Old Model and New Model

Difference Comparison about Waterproof Enclosure

PEDSC-EL
Waterproof Enclosure

PEDSC-EL
Waterproof Enclosure

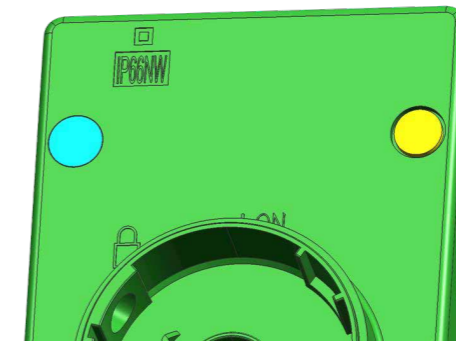
ON, OFF Instructions are not clear

Added ON, OFF direction indication ON, OFF by laser marking, more clear
